903.2.10

Sprinklers in Group S-2 Enclosed Parking Garages

Sprinkler protection of Group S-2 enclosed parking garages

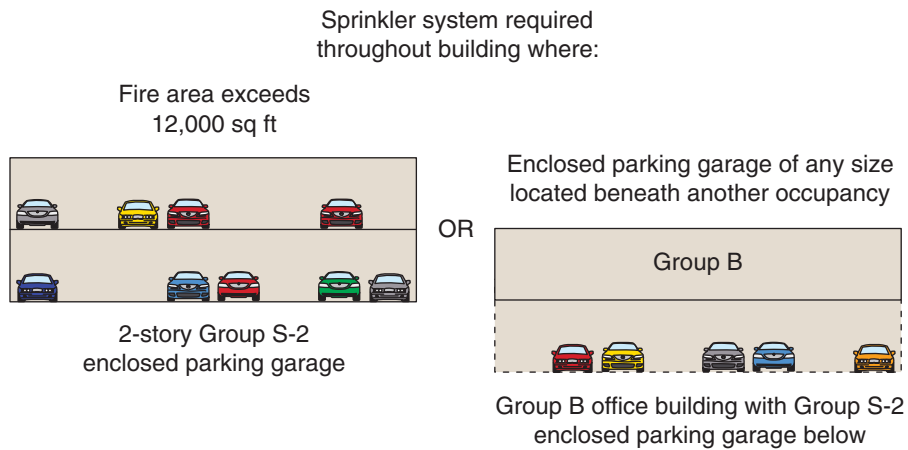
CHANGE SUMMARY: Unless located beneath occupancy groups, Group S-2 enclosed parking garages now require automatic sprinkler protection only where the fire area containing the parking garage exceeds 12,000 square feet.

2009 CODE: 903.2.9 903.2.10 Group S-2 Enclosed Parking Garages. An automatic sprinkler system shall be provided throughout buildings classified as enclosed parking garages in accordance with Section 406.4 ~~or where located beneath other groups~~ as follows:

1. Where the fire area of the enclosed parking garage exceeds 12,000 square feet (1115 m²); or
2. Where the enclosed parking garage is located beneath other groups.
